Re: My Opposition to the Portage Avenue Apartments

Portage Road Apartments

Map attached

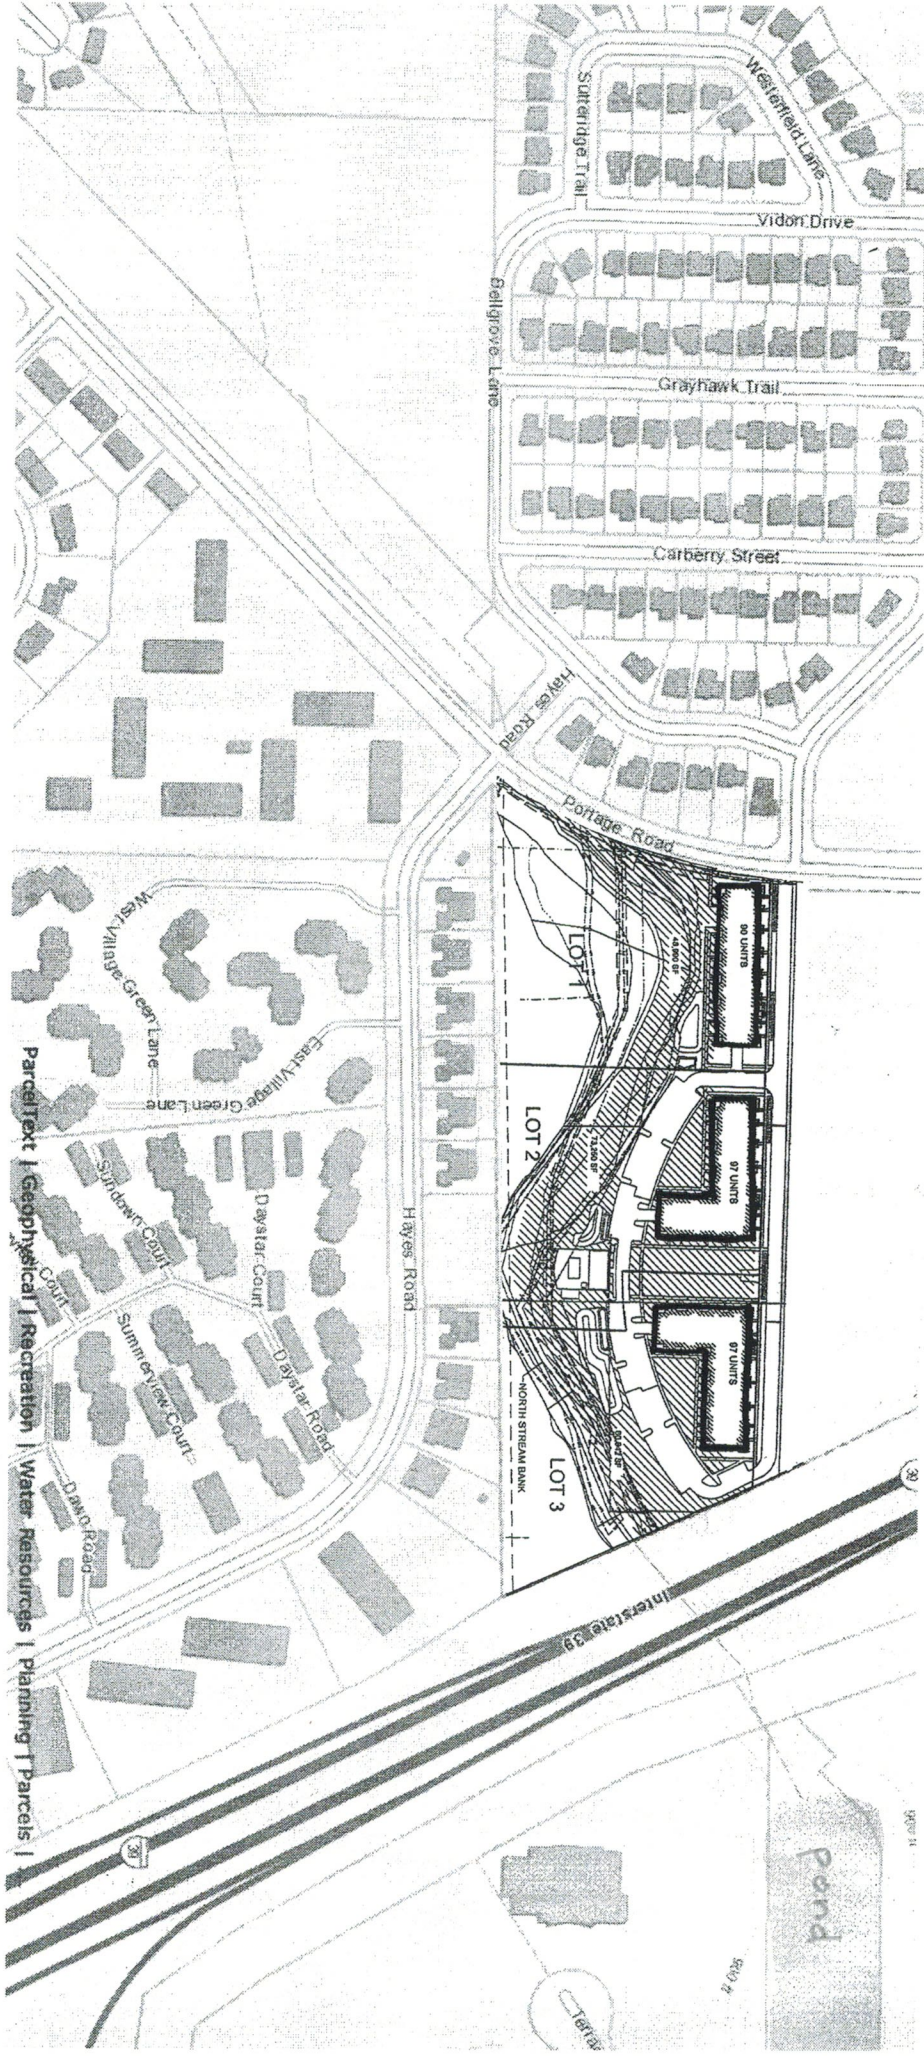
This property is supposed to be a transition from medium to low density. The attached map clearly shows that it will look like the largest and densest development in the area. The City is clearly not obligated to approve 284 units on this site, but has calculated density in such a way that it appears to meet the Comp Plan requirements. We are choosing this density and I think that's a mistake.
